STAFF REPORT: APRIL 10, 2024 MEETING

APPLICATION NUMBER: HDC2024-00142

ADDRESS: 3627 LINCOLN

SCOPE: ERECT FRONT PORCH

Figure 4, by Applicant: showing proposed color scheme. (Please note colors in figures 1-3 above are not accurate.)

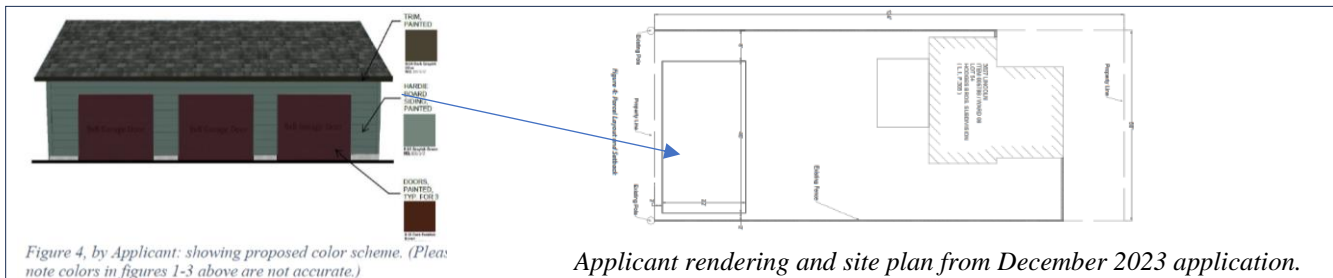
- The porch and railings, based on their design, materiality, and finishes, are compatible with the historic appearance and character of the building. However, it is staff’s opinion that the selected door is not compatible with the primary façade due to its materiality, texture, and visual qualities:

- The selected door is a fiberglass product that “mimics” the texture of wood grain. Based on the promotional material on the company’s website, this door is likely similar to vinyl siding products that offer a raised grain to “mimic” wood siding, overlooking the fact that real wood products don’t have highly visible, raised grain surfaces. A fiberglass door stain kit is sold as a finish color option.

- The door opening is a focal point of the primary façade. The materiality, texture, and finish (i.e., no sheen) should be compatible with the late 19th century historic appearance and character of the masonry building, as well as with the proposed new wood porch and iron railings.

- Wood doors, whose material and texture are compatible with the building and setting , are readily available on the market.
- To fully ascertain the finish of the proposed doors, staff will ask that a sample be provided so the Commission can review its appearance and texture at the meeting.

Recommendation One – Denial – Installation of fiberglass door with oak grain finish

Staff therefore recommends that the Commission issue a Denial for the work as proposed, as it does not meet the Secretary of the Interior’s Standards for Rehabilitation, specifically Standards 6 and 9:
